BALLARD MINE FEASIBILITY STUDY REPORT

MEMORANDUM 1 SITE BACKGROUND AND SCREENING OF TECHNOLOGIES

FINAL REVISION 2

Appendix C Comments and Comment Responses

SURFACE WATER, SEDIMENT, RIPARIAN SOIL/VEGETATION SAMPLE LOCATIONS

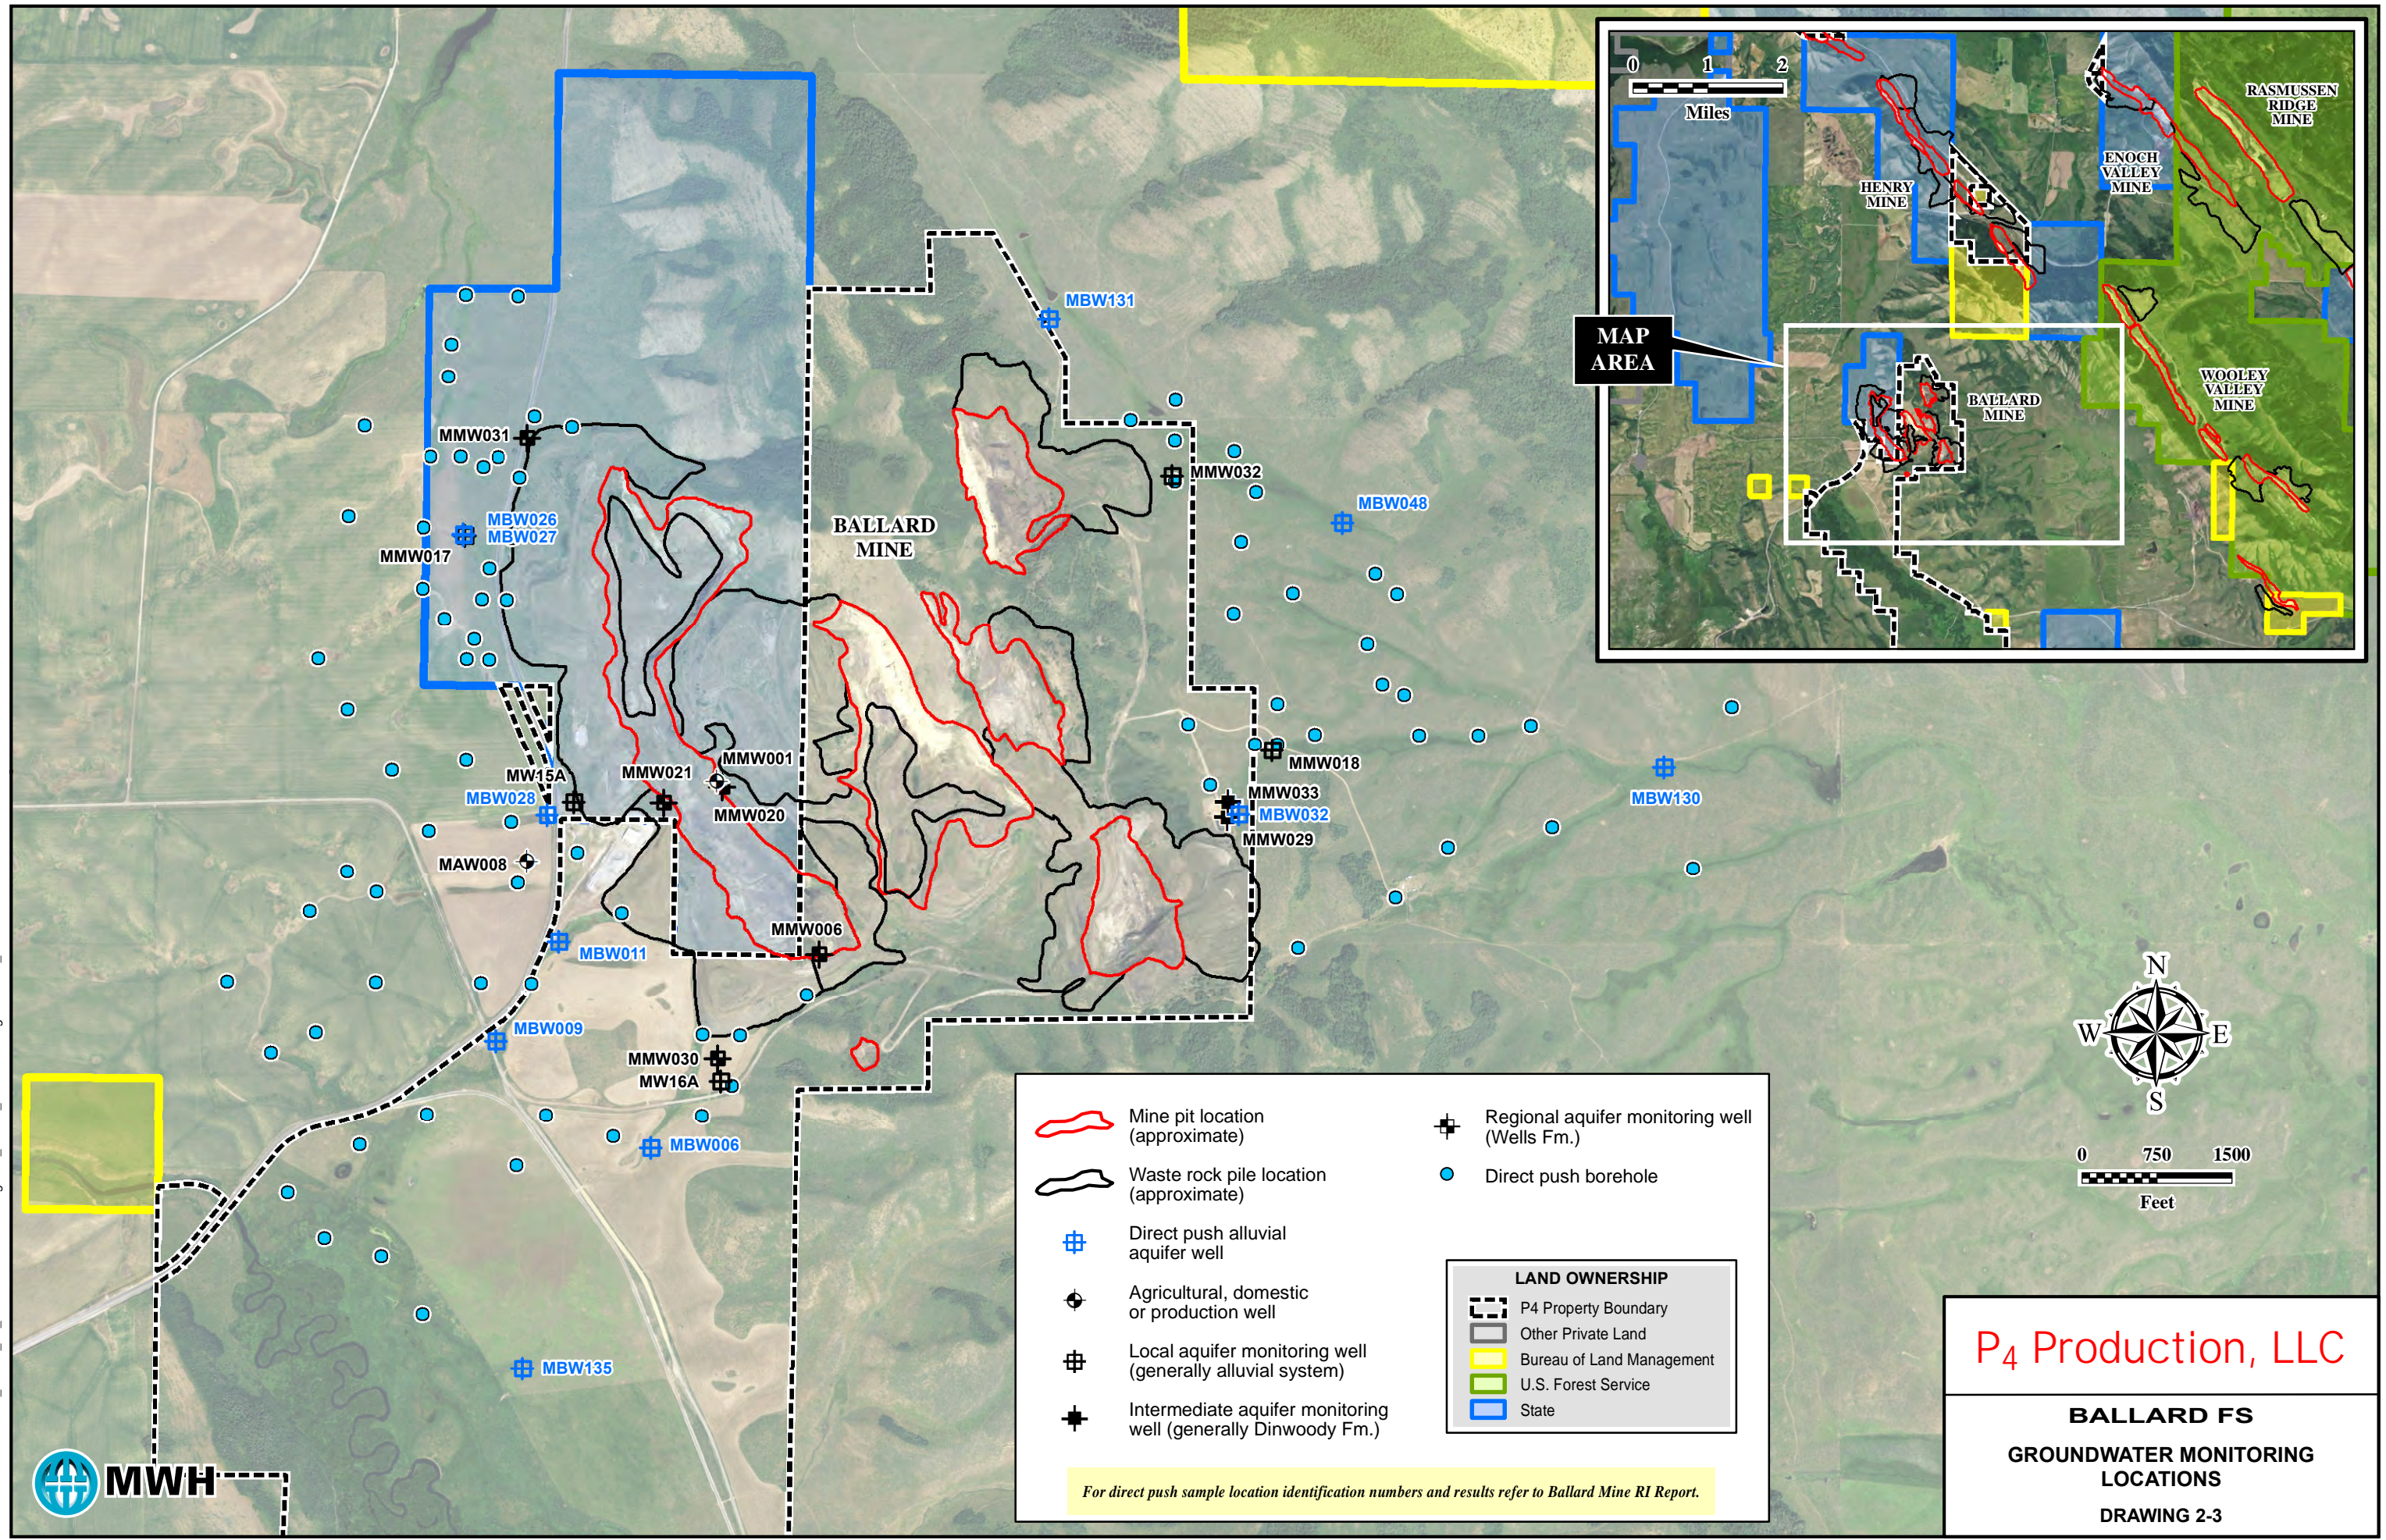
SC-36 **Drawing 2-2.** Does this drawing also include co-located sediment sample locations? Revise accordingly.

A/T Response to SC-36 Drawing 2-2. Revise the title to include the fact that sediment locations are also included in this drawing.

***P4 Response (SC-36):** This drawing shows the station locations for surface water, sediment and riparian soil. It does not show the exact sample locations. For example, during the 2010 supplemental sediment and riparian soil sampling, up to five sediment locations may have been collected from select pond and stream stations. The location of these samples on Drawing 2-2 is not necessary given that Section 2.0 of FS Memo #1 is a summary of the nature and extent of contamination at the Ballard Site. Also, the exact location of these samples would not be distinguished given the scale of the drawing. No revisions to Drawing 2-2 are necessary.*

***P4's Supplemental Response (SC-36):** The Drawing 2-2 title will be revised to "Surface Water, Sediment, and Riparian Soil and Vegetation Sample Locations."*
